**County of San Diego  
Planning & Development Services  
BUILDING DIVISION**

ACCESSIBILITY CORRECTION LIST

Multifamily Housing

**Public Telephones**

(b) FORWARD APPROACH  
FIGURE 11A-11B  
TELEPHONES

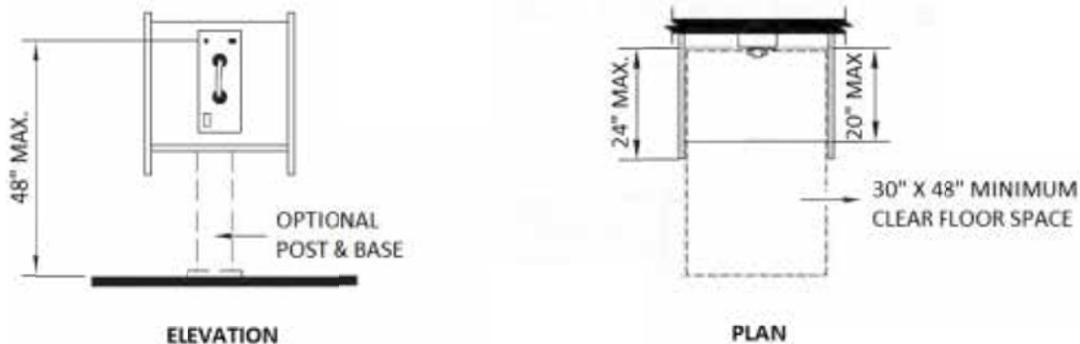
5. Dimension wheelchair clear floor/ground space complying with the following at each accessible telephone:
- Minimum 30 inches by 48 inches
  - Allowing forward or parallel approach
  - One full unobstructed side adjoining another wheelchair clear floor/ground space

CBC 1140A.2 and CBC 1140A.3

6. Dimension telephone mounting height and any enclosures per the following:
- Where only forward approach allowed, per CBC Figure 11A-11B(b)

(a) PARALLEL APPROACH  
FIGURE 11A-11B  
TELEPHONES

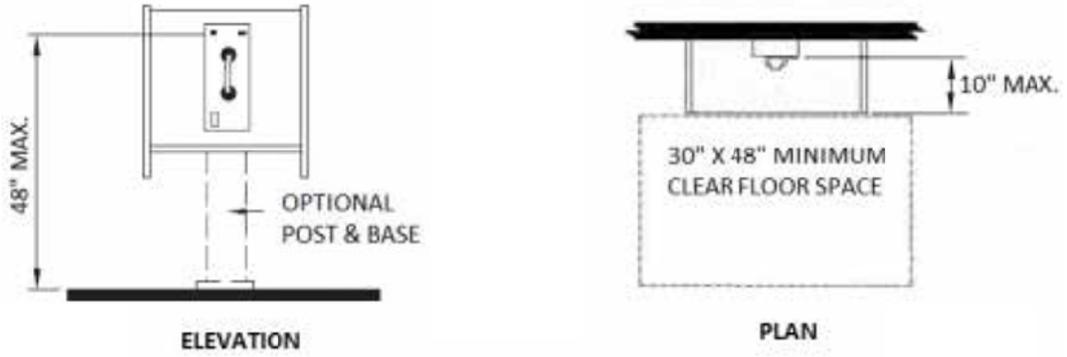
- Where parallel approach allowed, per CBC Figure 11A-11B(a)

CBC 1140A.4
